EU Directive on Brake Assist

This proposal seeks to permit a pressure assessment option as an alternative to deceleration measurement in Cat A BAS. The **optimized DR booster** can then be recognised as a BAS

Regulation 13-H, Annex 10

A Proposal.

Acceptance criteria for force sensing devices

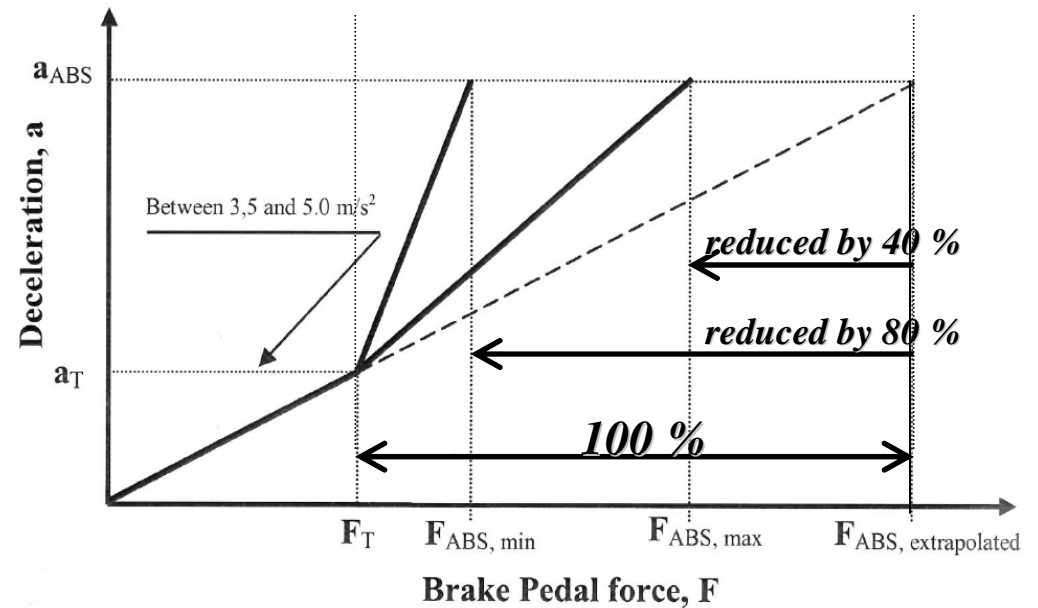
This appears to be based on the underlying assumption (shown dotted) that the projected braking characteristic will be **linear**.

However,

THIS IS NOT ALWAYS THE CASE !

Pedal Effort v Deceleration
Progressive application from 80 Km/h

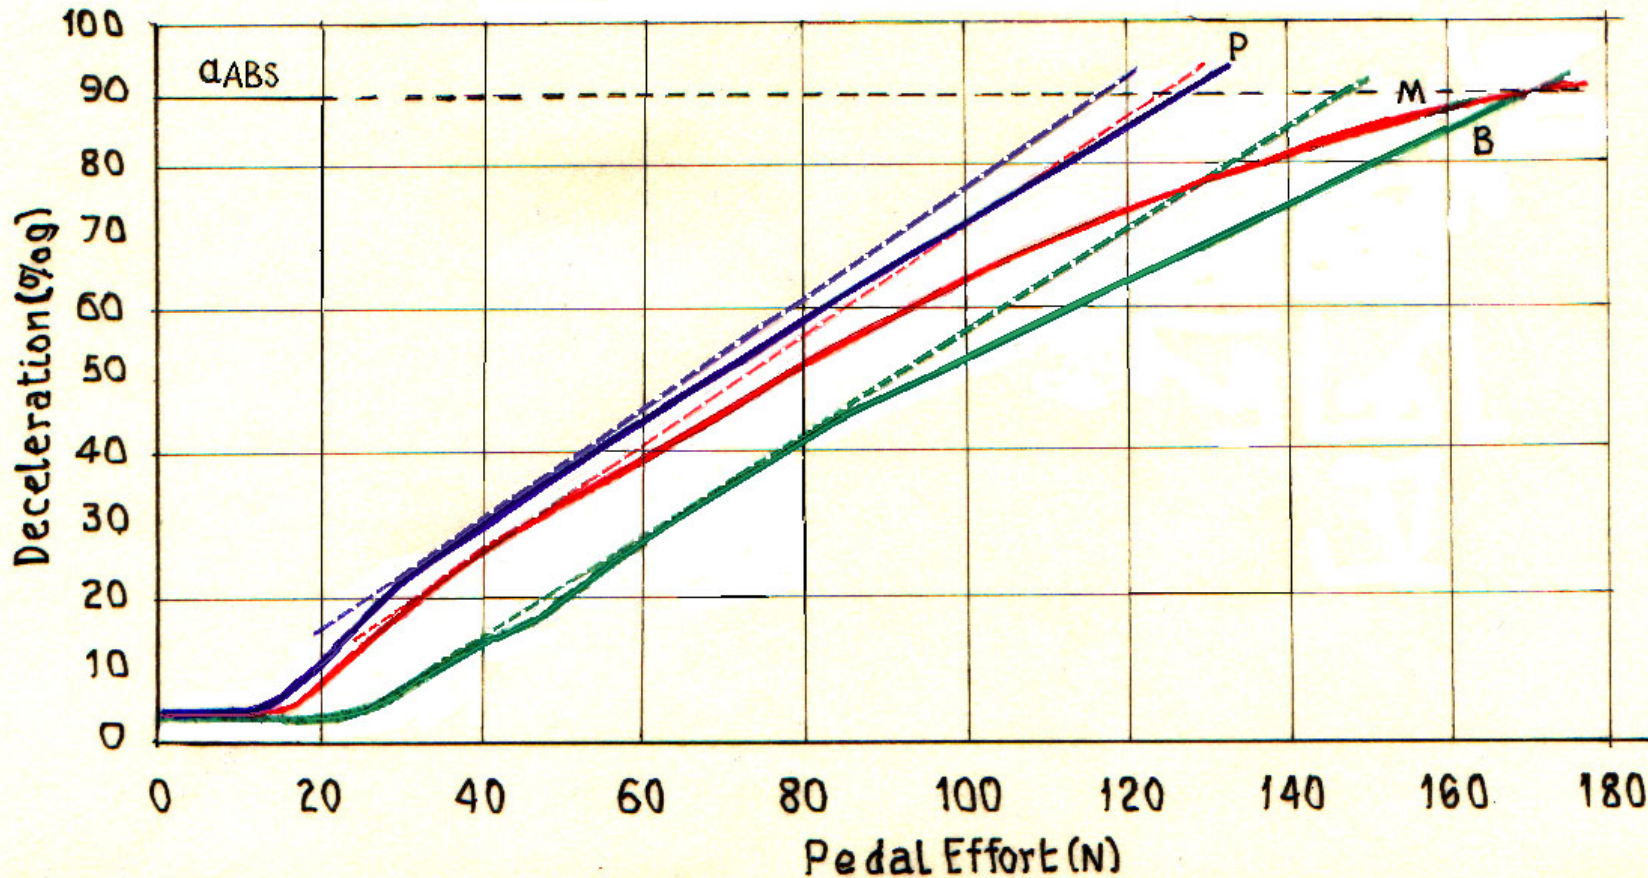
Linearity depends on where the line drawn. Response **P** is the nearest to being linear. Response **B** is clearly not linear and **M** is notably non-linear at the high end

Optimized Dual Rate (DR) Booster

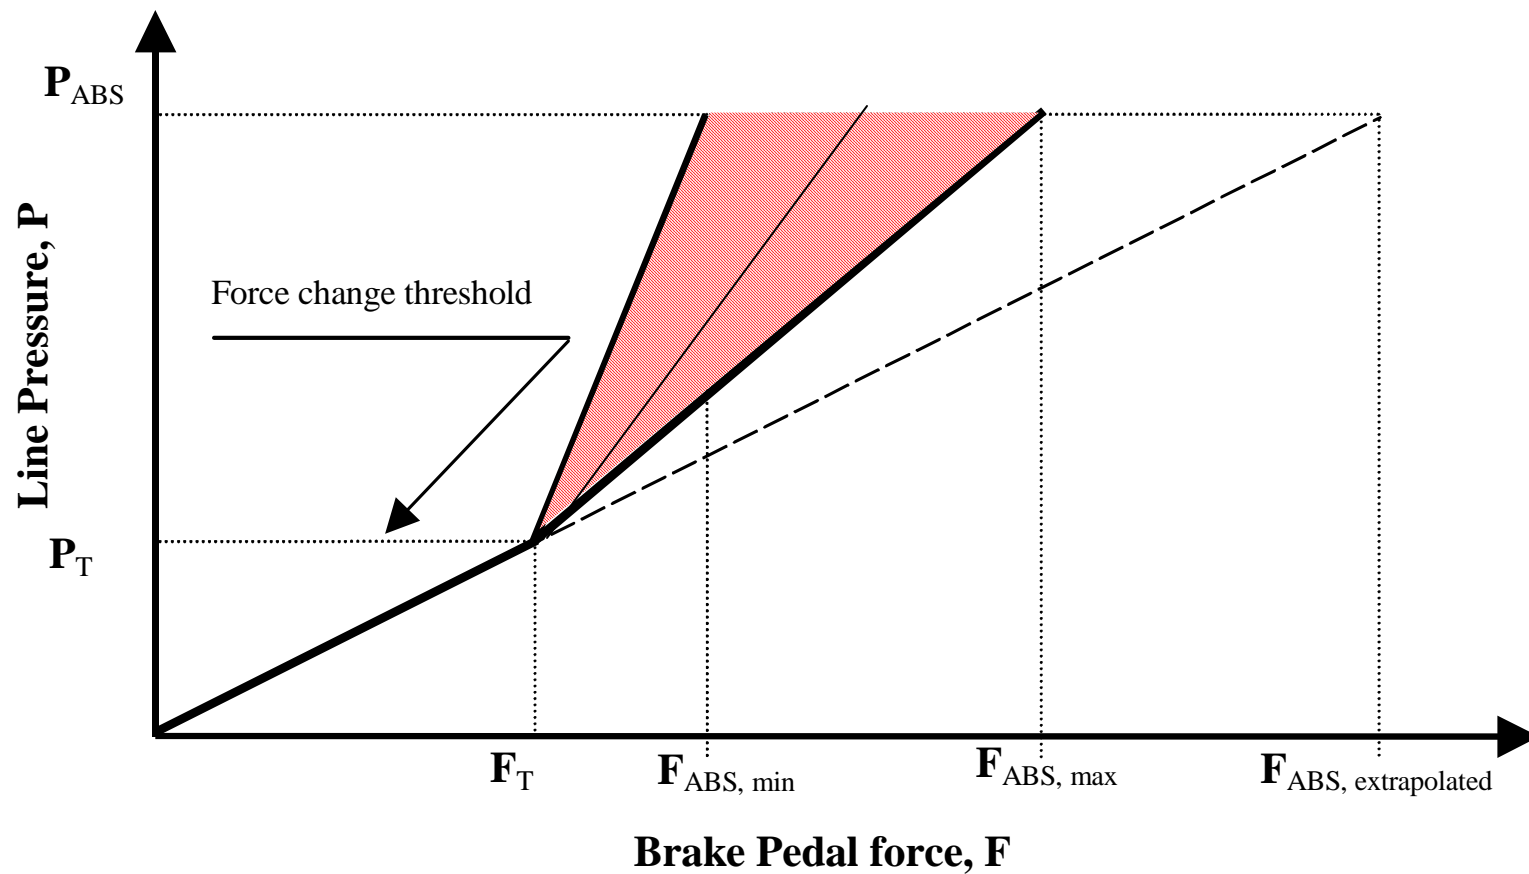
Conclusion from pressure measurement:

with DR the Pedal force reduction is met if : $40\% < \frac{(F_{\text{ABS extrapolated}} - F_{\text{ABS}})}{(F_{\text{ABS extrapolated}} - F_{\text{T}})} < 80\%$

measurement shows $40\% < 60\% < 80\%$

Pedal Force reduction is significant & the...

Requirement for Force based Brake Assist is fulfilled.

Figure 1b

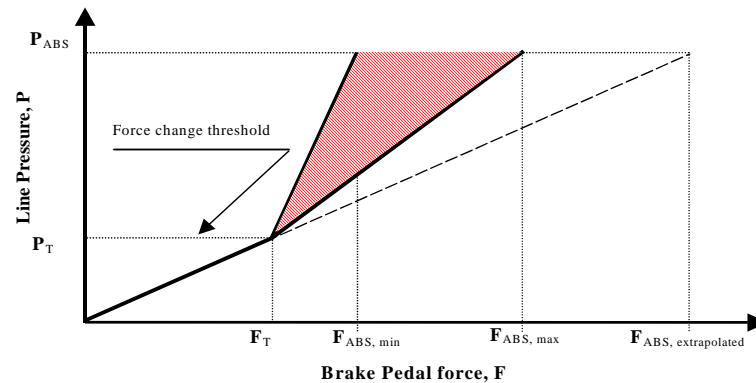
Add an additional paragraph 3.2.5. and amend the title of Figure 1 to read Figure 1a and add an additional Figure 1b.

“3.2.5. As an alternative, which can be selected by the manufacturer, the pedal force figures for F_T , $F_{ABS,min}$, $F_{ABS,max}$ and $F_{AB,extrapolated}$ may be derived from the brake line pressure response characteristic instead of the vehicle deceleration characteristic. This shall be measured as the brake pedal force is increasing.

3.2.5.1. The pressure, at which ABS cycling commences, shall be determined by making five tests from 80 km/h in which the brake pedal is applied up to the level which produces ABS operation and the five pressures at which this occurs as determined from front wheel pressure records, shall be recorded and the mean value obtained as P_{ABS} .

3.2.5.2. The threshold pressure P_T shall be stated by the manufacturer.

3.2.5.3. Figure 1b shall be constructed in the manner set out in paragraph 3.2.4. but using line pressure measurements to define the parameters set out in paragraph 3.2.5 above where:

$$F_{ABS,extrapolated} = \frac{F_T \times P_{ABS}}{P_T}$$
